Subject: EPA summary of Action items on Sediment and Floodplain soils December 13 Presentation

During the presentation of Stream Sediment/Floodplain Soil Investigations. ARC offered EPA the following reporting options:

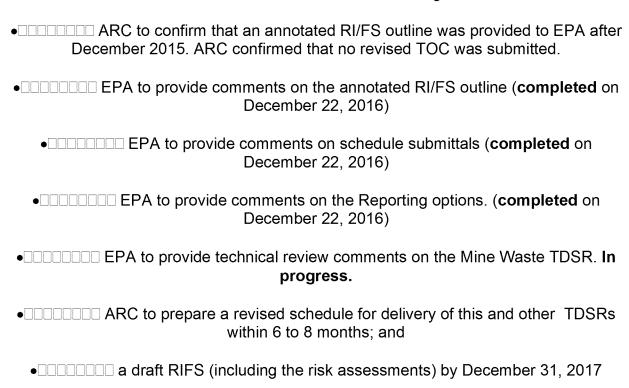
EPA noted that neither of these options include reports with data from Floodplain Soil collected during the 2016 field season.

Nor do these options reflect EPA past comments requesting expedited turnaround on reports.

In our most recent letter, (December 22 2016) EPA clarified and directed that these submittals should be considered Draft RI/FS sections that includes both validated analytical data as well as data interpretation and risk assessment summaries. EPA directs ARC to ensure the interim TDSR submittals are sufficiently scheduled to ensure delivery of a first inclusive <u>draft RI/FS</u> by December 31, 2017 and a complete and <u>final RI/FS</u> by August 30, 2018. To achieve that goal, EPA still holds that up to 6 months or 180 days is reasonable and follows EPA guidance and common practices at other Superfund sites. EPA is not opposed to extending that delivery time to 8 months (240 days).

Please provide the stream sediment and Floodplain Soil TDSR's for both 2015 and 2016 data to allow for this schedule. Six to eight months from the date of last 2016 sampling (October 2106) would entail ARC provide the 2016 sediment and floodplain data (combined report) to EPA by June 2017. Please see our draft agenda (below) indicating some of the basic specific data presentation options that should be included.
